INNER WEST COUNCIL

DEVELOPMENT ASSESSMENT REPORT

Application No.	D/2018/473
Address	25 Maida Street, Lilyfield
Proposal	Alterations and additions to existing dwelling including new first floor
Date of Lodgement	7 September 2018
Applicant	Fiona Pickett-Hears Design
Owner	A White
Number of Submissions	Nil
Value of works	\$228,640.00
Reason for determination at Planning Panel	Clause 4.6 variation exceeds officer's delegation
Main Issues	<ul style="list-style-type: none"> • FSR variation greater than 10% • Non-sympathetic attic addition
Recommendation	Refusal
Attachment A	Recommended reasons for refusal
Attachment B	Plans of proposed development
Attachment C	Clause 4.6 Exception to Development Standards
Attachment D	Standard Conditions

Figure 1: existing and proposed street elevations

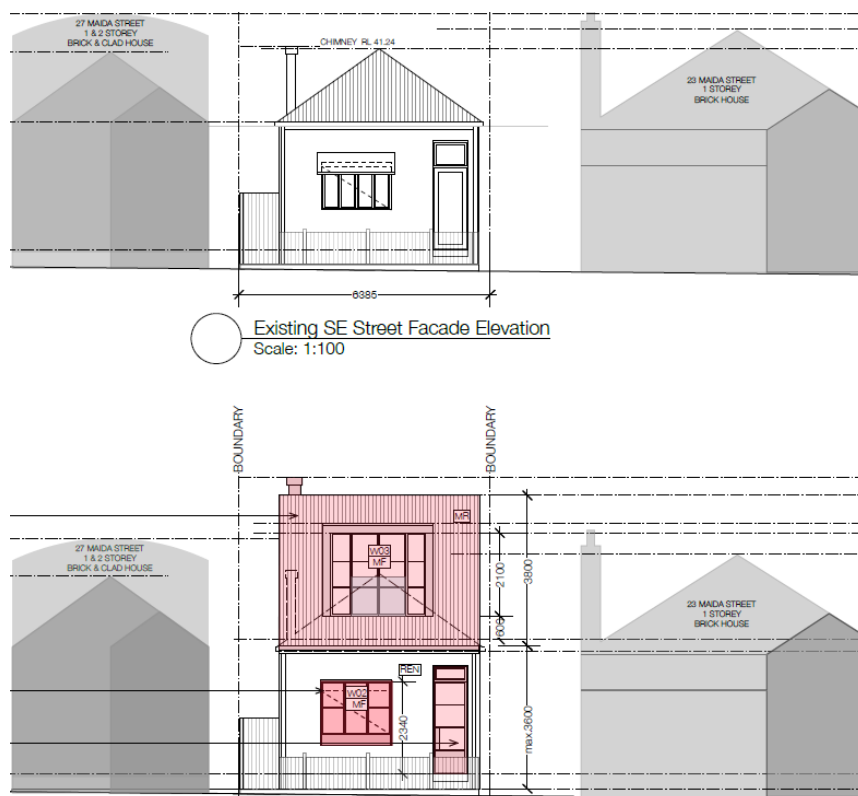
- The proposal is not compatible with the desired future character of the Nanny Goat Hill area in relation to building bulk, form and scale;
- The proposal, namely the first floor addition is not sympathetic to the existing dwelling or the surrounding dwelling along the Maida Street streetscape;
- The minimum lot size development standard is not indicative of an ideal lot size within the LGA but rather sets controls for subdivision if the objectives of the clause are satisfied. As such, the subject site does not enjoy special consideration as ‘undersized’;
- The existing dwelling has adequate internal amenity to satisfy the needs of the residents and a revised first floor addition that is modest in scale and is sympathetic to the existing streetscape can be accommodated on the site to improve the internal amenity of the dwelling.

The drawings below (provided by the applicant) illustrate the relationship of the proposed building with its neighbours, showing the over-scaled nature of the proposed addition:

EXISTING & PROPOSED STREET ELEVATION

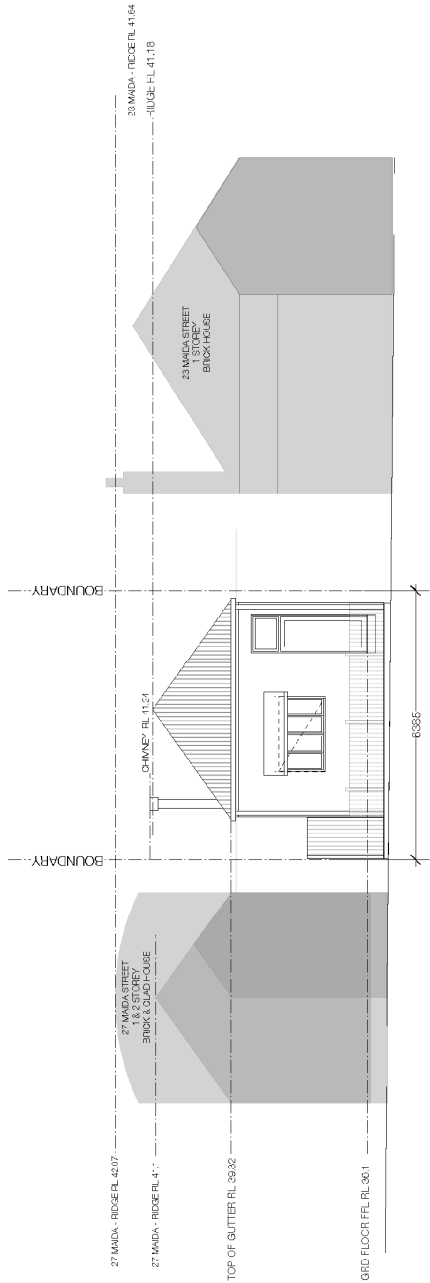
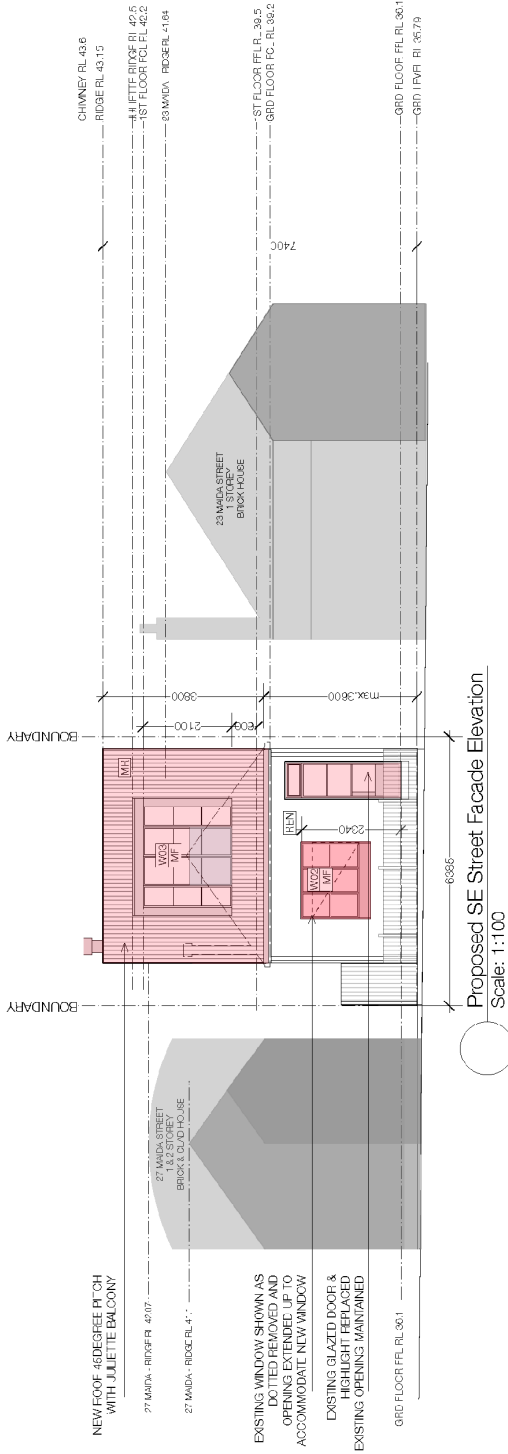
- *Subclause O4, to ensure that all residential development is compatible with the scale, form, siting and materials of existing adjacent buildings; and*
Comment: The gable style first floor addition with front dormer window is excessive in scale and has not been designed with consideration to the site layout and building controls of the LDCP 2013. There are no dwellings within Maida Street that have a front dormer window as significant in scale as to that proposed for the subject site. Although Maida Street consists of a variety of single and two storey dwelling types, as previously stated dwelling houses with first floor additions generally have preserved a portion of the existing roof form and setback the first floor addition further to the rear. Examples of these type of additions can be found at 15, 16, 18, 20, 22, 27 and 28 Maida Street.

Comment: Not acceptable. The first floor addition has not been articulated with consideration to the residential provisions of the LDCP 2013. The gable style roof, front dormer window, FSR exceedance, high ground floor ceilings and limited side, front and rear setbacks contribute to excessive and unnecessary bulk of the overall proposal.
